# **ADDENDUM NO. 1**

# WASHINGTON STATE PARKS AND RECREATION COMMISSION NORTHWEST REGION HEADQUARTERS NW REGION HQ REMODEL NW-C35NW

DATE: December 18, 2024

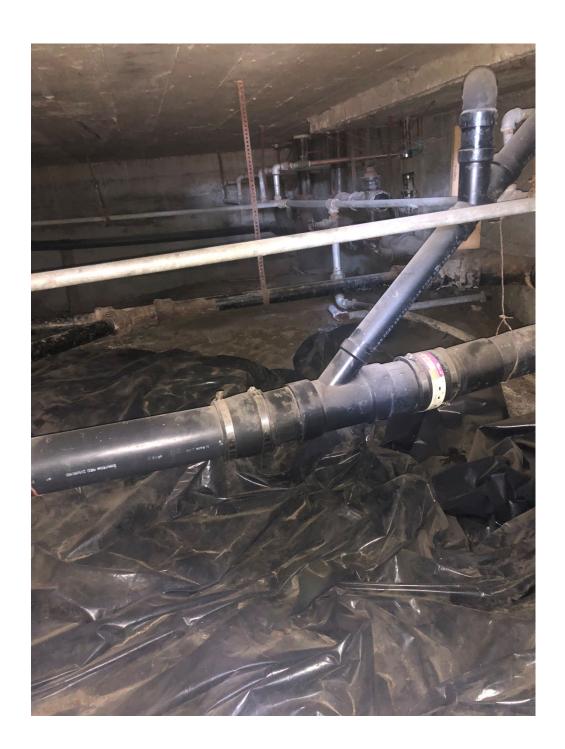
f. What does it look like in the crawlspace under the existing restrooms? See photos (left to right in numerical order looking in from south wall access door)
